FOUNDATION INVESTIGATION
WP-142-63
DEUX RIVIERES CREEK BRIDGE
HIGHWAY NO. 17
DEUX RIVIERES, ONTARIO

Foundation Investigation
MP 142-63
Deux Rivières Creek Bridge
Highway No. 17
Deux Rivières, Ontario

Deer Riveron Creek Culvert
-- Structural Pipe Arch --
*P. 142-63 -- Site No. 29-2
Highway 17, District No. 13

Deux Rivieres Creek Culvert
Structural Pipe Arch
K.P. 142-63, Site No. 29-2
Highway 17, District No. 11

SKETCH SHOWING SUGGESTED METHOD OF EXCAVATING FOR
BRIDGE OR ARCH FOUNDATIONS

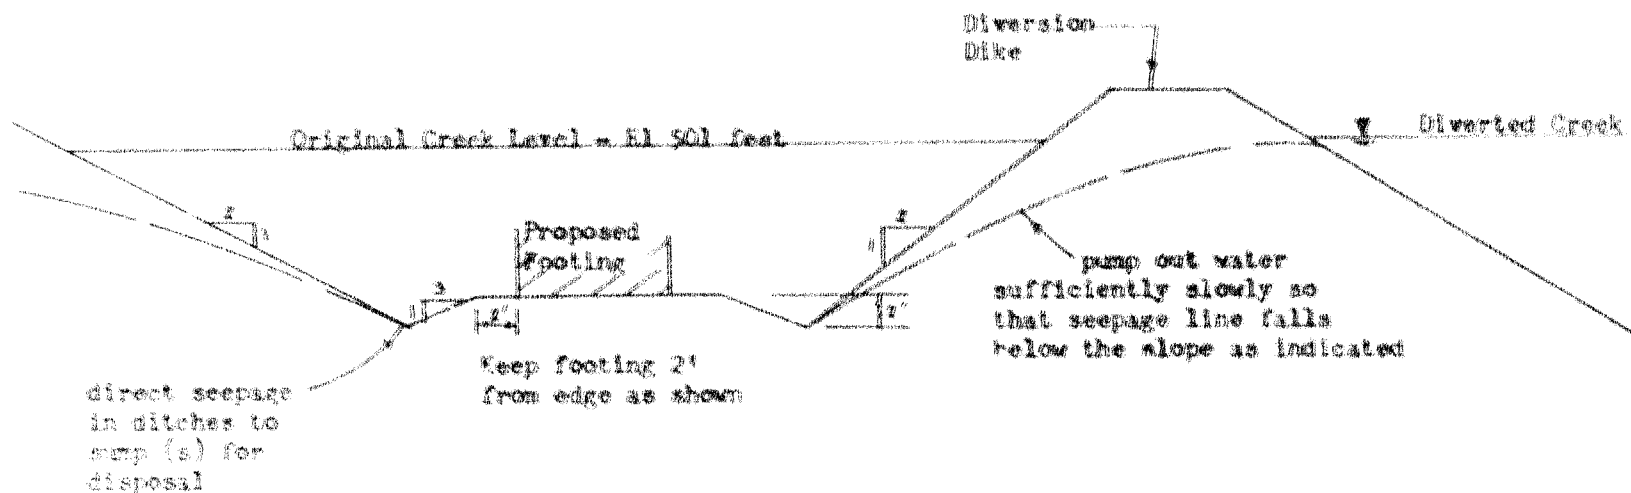
3) The sand, gravel and boulders are thought to be relatively free draining. Because of the numerous boulders, ringing the excavations with sheet piling will be difficult. Consideration should be given to diverting the stream to one side of its channel, with a dyke, and digging oversize footing excavations on the other side. Excavations large enough to accommodate drainage ditches will be required. It is recommended that digging be carried out underwater until the excavation is down to about final grade (See Dag. 7). The water can then be pumped out gradually, allowing the water to drain from the side slopes so they will remain stable.

- PROCEDURE:-
- 1) Divert Creek
 - 2) Excavate below water level to approximate dimensions shown
 - 3) Pump out water
 - 4) Prepare footing bed and install footing
 - 5) Backfill with sand and gravel and cover with rip rap

DRAWING <u>P. SCH.</u>
DATE <u>JUNE 1967</u> | | CHECK: _____
CHECK <u>P. O.L.</u>
LOADING <u>HIS 20-44</u> | | CONTRACT No. _____
No. _____ | | _____
_____ | | DRAWING No. <u>D-6177-P1</u> | |

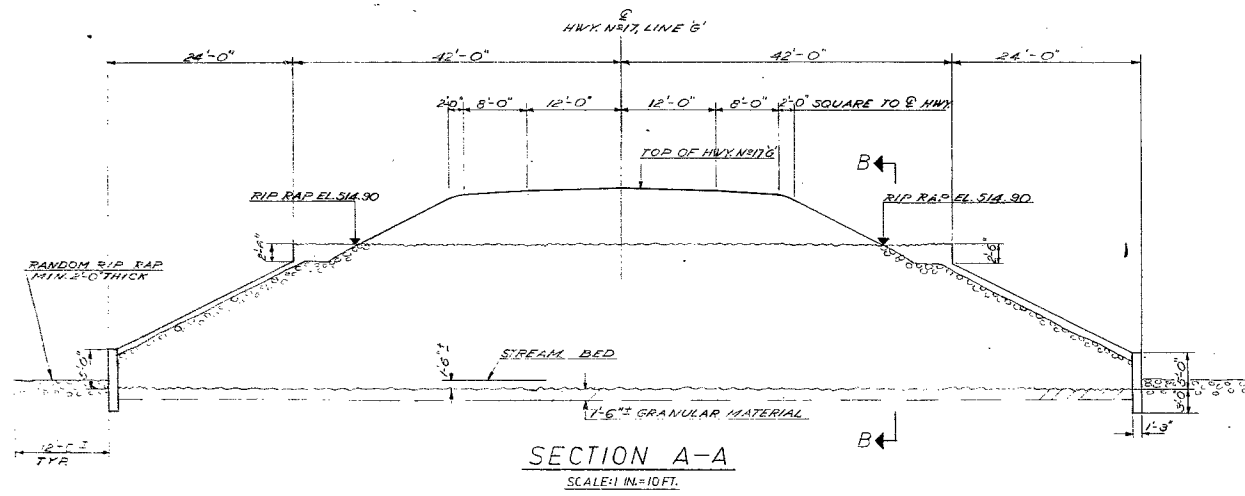
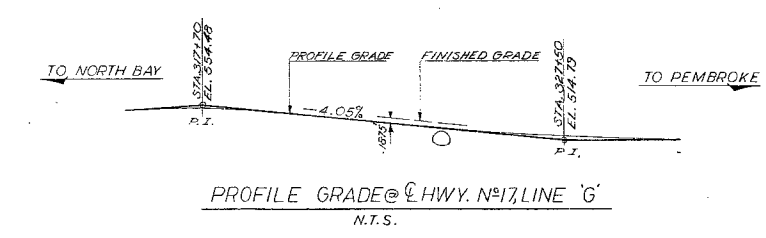
We have reviewed the Preliminary Bridge Drawing No. B-6177-P1 for the above-named structure. We note that you have decided to use a pipe arch culvert instead of either of the originally proposed structures.

We would like to emphasize that a dewatering scheme will be required, since excavations will be carried out below the creek water level for the proposed structure in granular subsoil.
